**From:** Cieslak, Douglas J - DNR  
**Sent:** Wednesday, July 22, 2015 5:05 PM  
**To:** Mylotta, Pamela A - DNR  
**Subject:** FW: Superior Health Linens - 2-10-2015 Workplan - BRRT 02-41-532649 FID 241780880

Reference: *Work Plan for Additional Site Investigation*  
Superior Health Linens  
5005 South Packard Avenue  
Cudahy, Wisconsin  
BRRTS #02-41-532649  
FID #241780880

Subject: Technical Assistance Superior Linens - BRRT 02-41-532649 - FID 241780880

Figure 1 – Site Layout  
DNR letter from Doug Cieslak, re: Technical Assistance Request, dated 1/21/2015

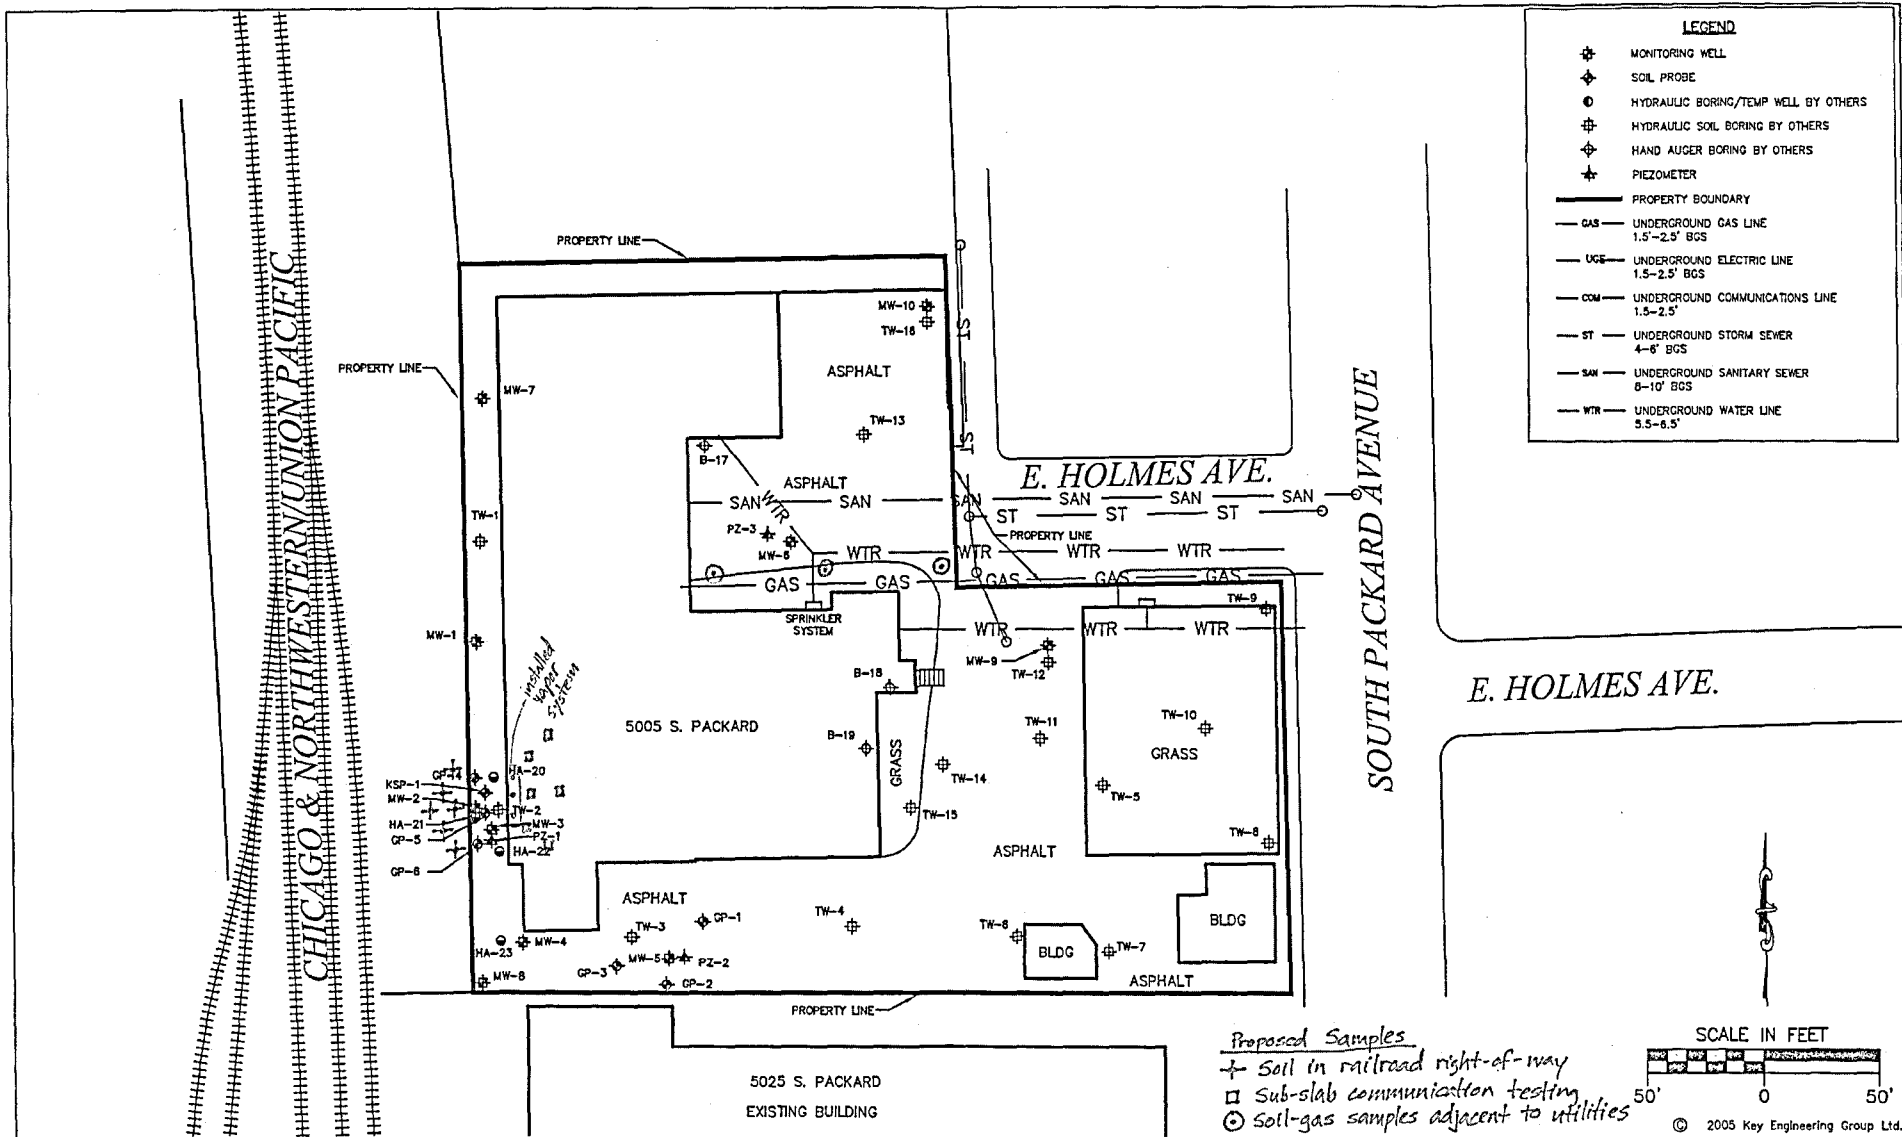
According to your map you intend to collect additional soil and groundwater samples on the railroad property within 20 feet from your previous sampling on the subject property. No permanent monitoring wells are proposed. Sampling this small of an area may not yield data necessary to define the horizontal extent of groundwater contamination. Also, using the Department's guidance, *Understanding Chlorinated Hydrocarbon Behavior in Groundwater*, RR-699, a permanent upgradient clean well is necessary for assessing the geochemistry of the groundwater entering the plume and any contaminants entering the plume. I recommend establishing a permanent monitoring well for this purpose. Some of your deepest soil samples from below the

water table ~26ft contained high concentrations of contaminants. I recommend collecting sufficient soil samples to help guide your remedial options analysis. This should include the historic ingress/egress beneath the southwest corner of the building.
